METROPOLITAN GOVERNMENT OF NASHVILLE AND DAVIDSON COUNTY

STAFF RECOMMENDATION
1900 Beechwood Avenue
January 20, 2021

Application: New Construction—Addition and Outbuilding; Setback Determination
District: Belmont-Hillsboro Neighborhood Conservation Zoning Overlay
Council District: 18
Base Zoning: RS 7.5
Map and Parcel Number: 10416017500
Applicant: Shannon Stark
Project Lead: Melissa Baldock, melissa.baldock@nashville.gov

Sheet #	L002	SITE PLAN	Date	12/12/2020	Scale	3/32"=1'-0"
	LANG Residence 1900 Beechwood Ave Nashville TN 37212

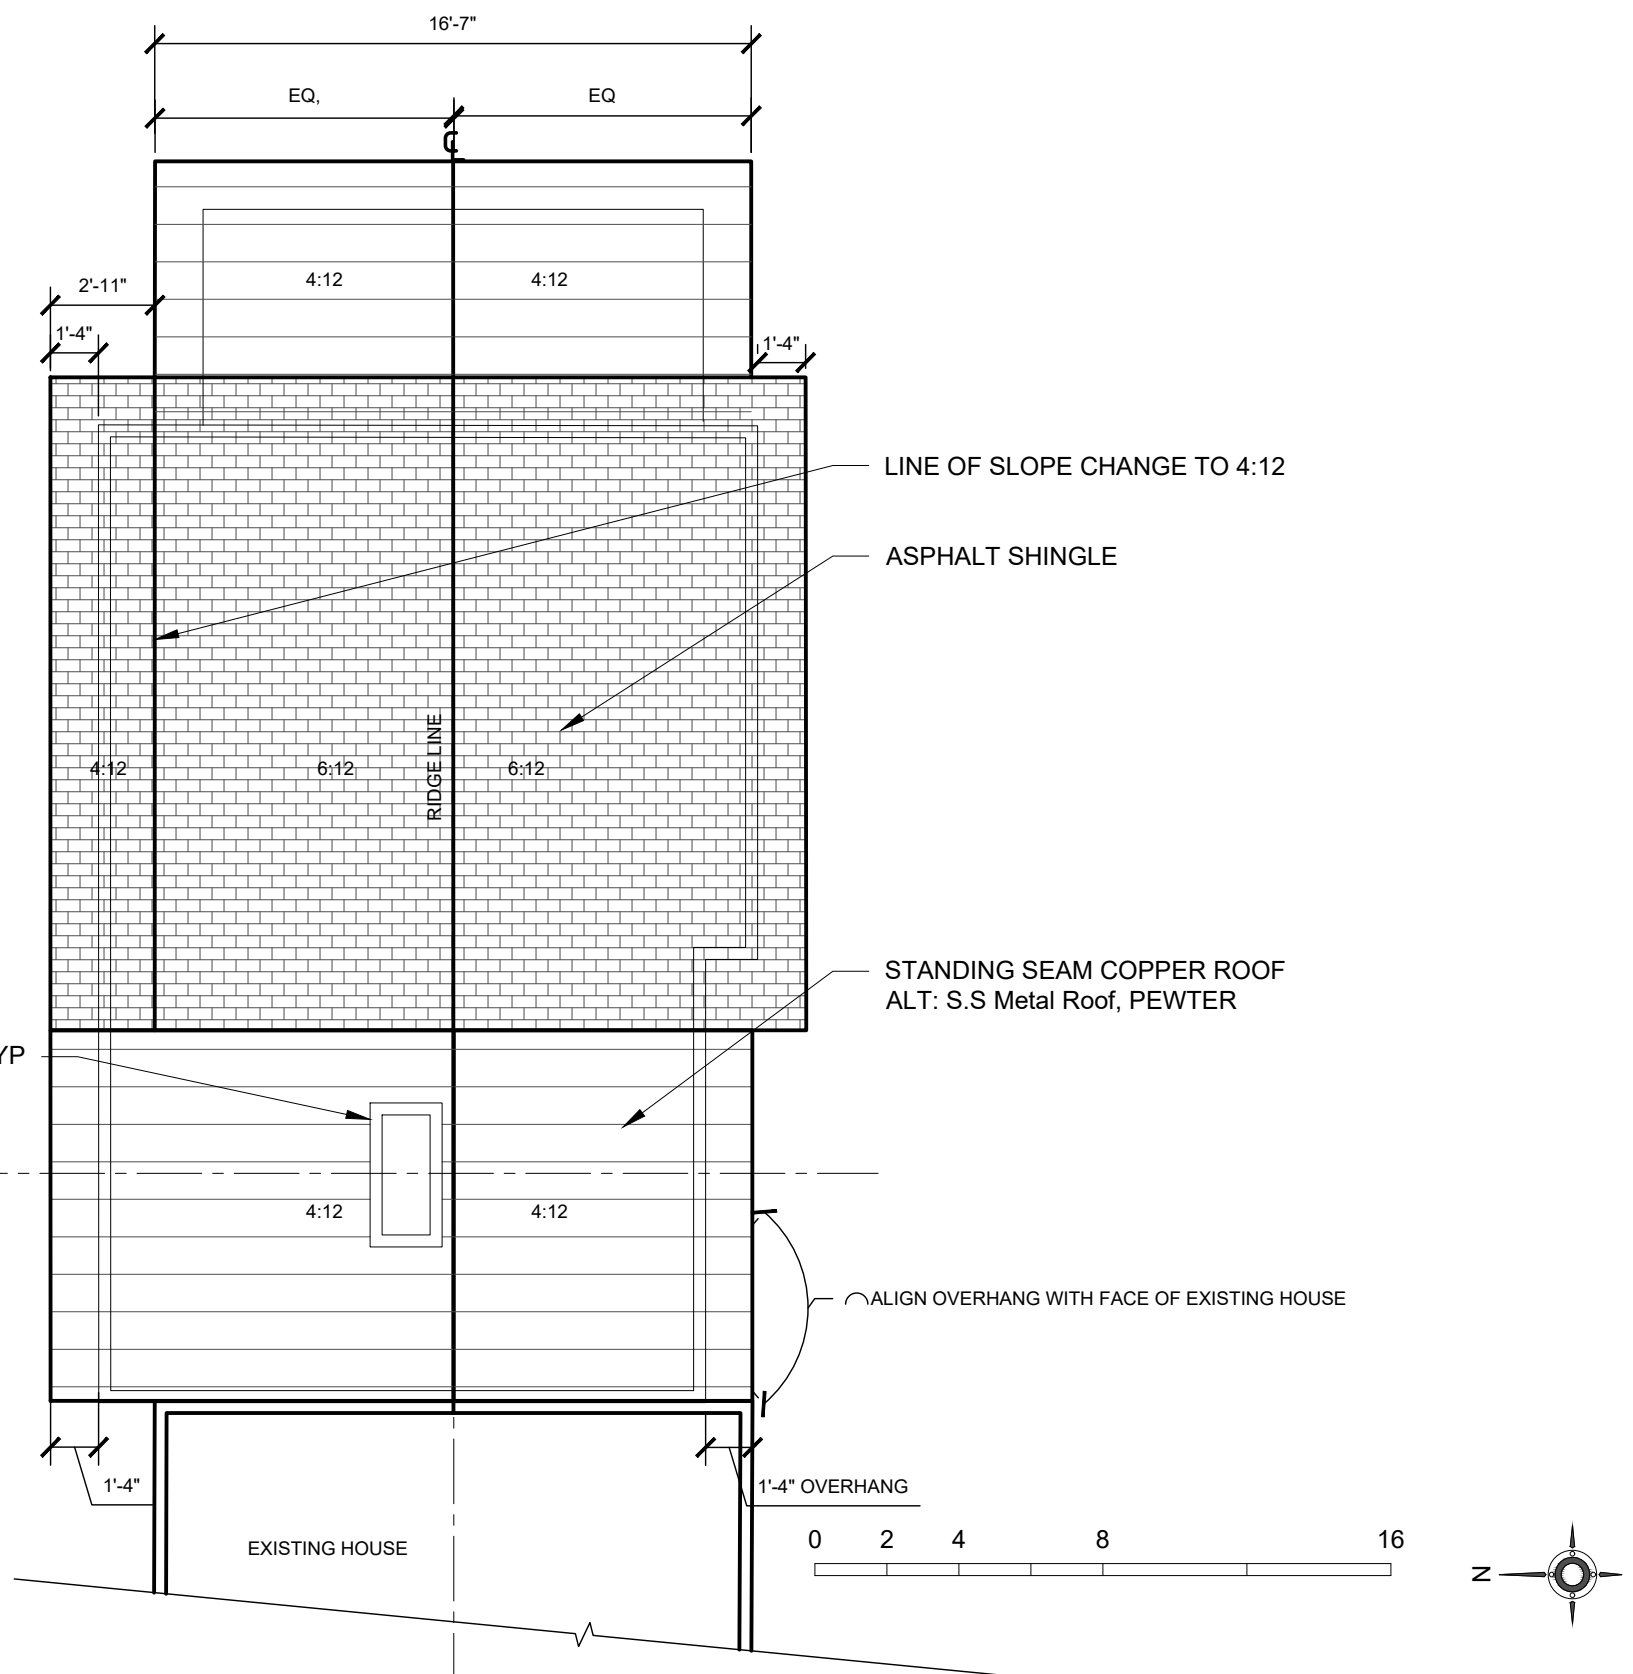
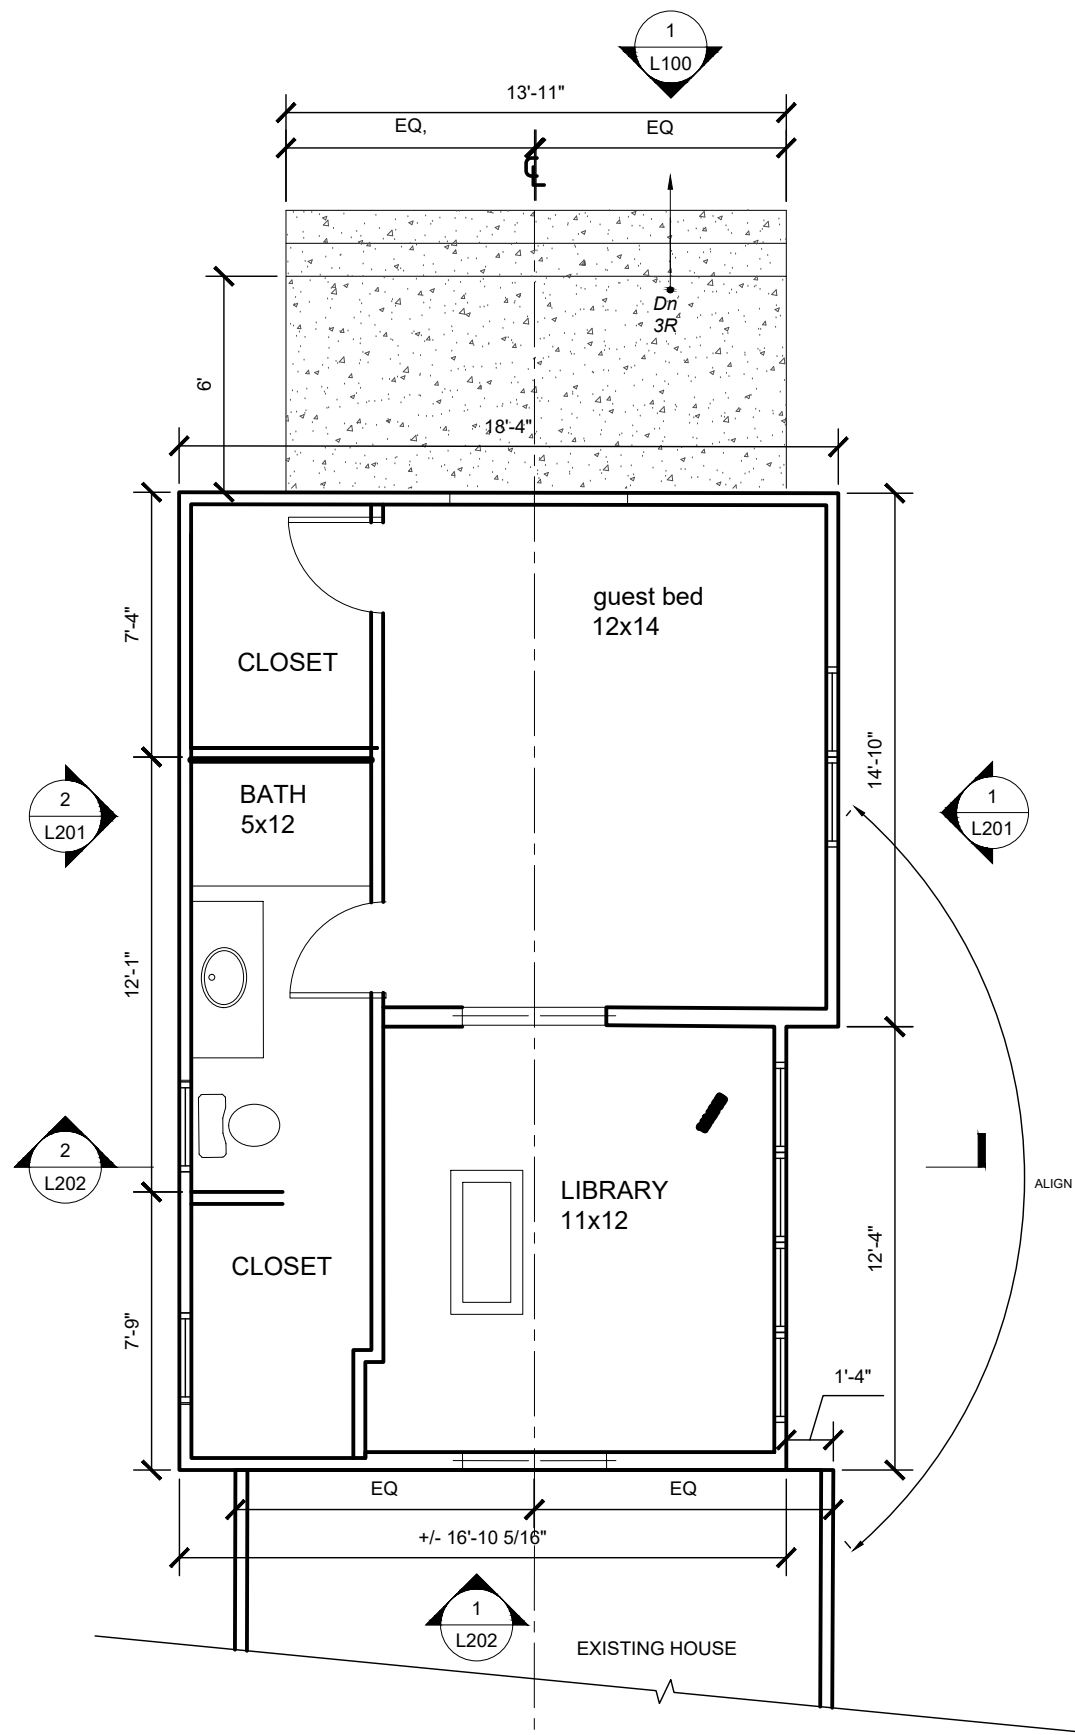
Setback & Rhythm of Spacing: The addition meets all base zoning setbacks and will not affect the rhythm of spacing of houses along the street. The addition will be five feet (5’) from the left property line, approximately twenty-six feet (26’) from the Altura Place property line, and over fifty feet (50’) from the rear property line.

MINIMUM	PROPOSED OUTBUILDING
Building located towards rear of lot	-	Yes
Space between principal building and garage	20'	54'
Rear setback – garage doors face alley	5'	2'10''*
Altura Side Property Line	10'	3'11''*
Interior left-side setback	5'	5'
How is the building accessed?	-	From alley
Two different doors rather than one large door (if street facing)?	-	N/A

*There is an existing one-story outbuilding on the lot that does not meet the side-street and rear setback requirements. The project will add a second story onto the existing outbuilding and will not change the outbuilding's footprint. Therefore, the setbacks will

not change from what they are now. Staff therefore finds that the proposed setbacks meet the design guidelines.
